Techno-Whizzy 1, Parts 1 & 2

Figure 1. The corrected schematic of the Techno-Whizzy 1 voltage regulator circuit, showing the proper placement of diode D1. Refer to Figure 3 in the December 1992 issue.

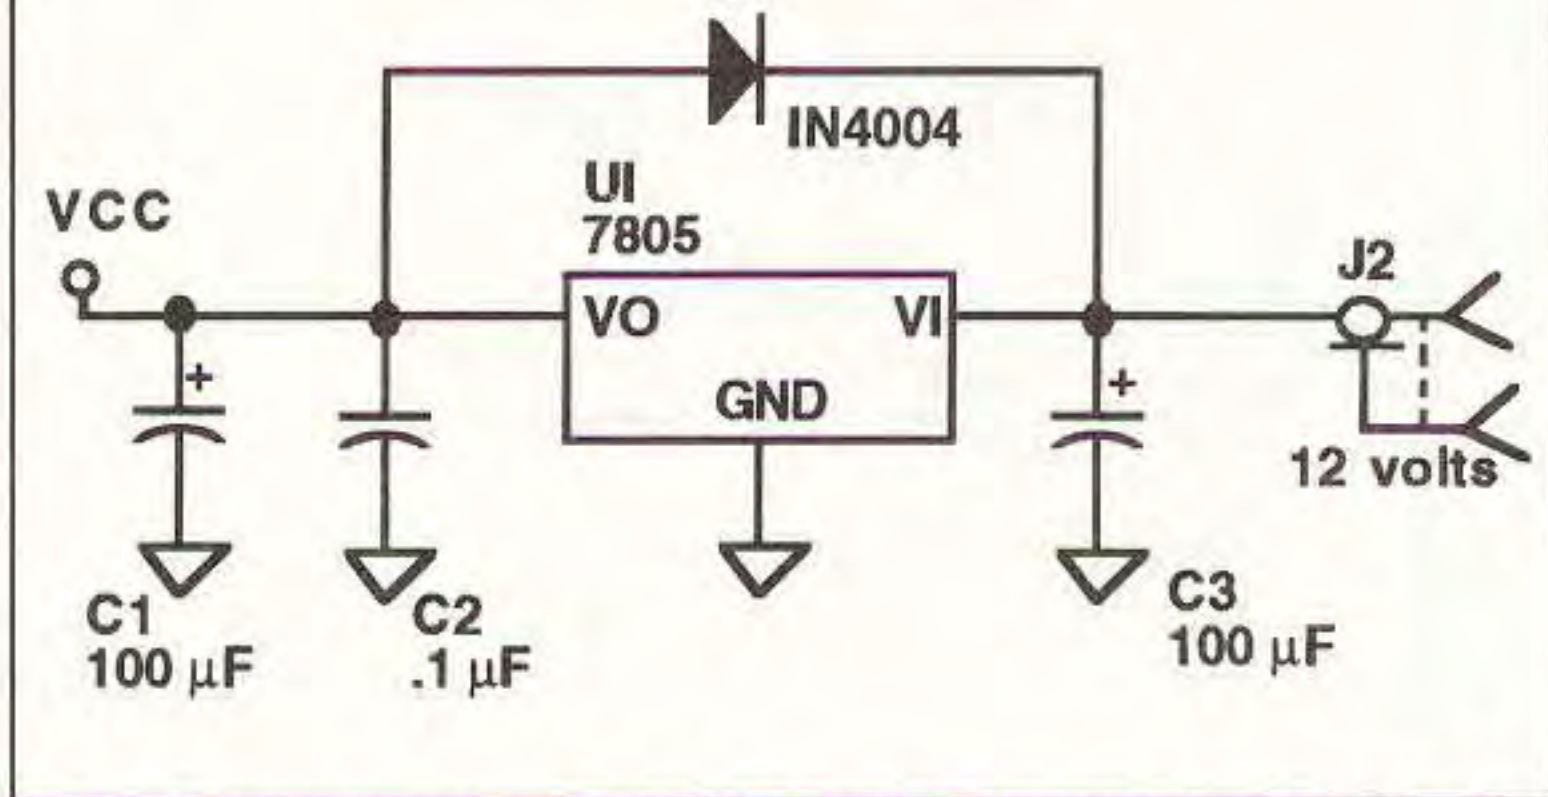
Refer to the above article in the December 1992 issue, page 12. Diode D1 is backwards in the schematic diagram (Figure 3), it should be installed as shown in Figure 1 below. Note that the diode position is shown correctly in the parts placement diagram in Figure 4b. *TNX to Joe Leikhim for the correction.*
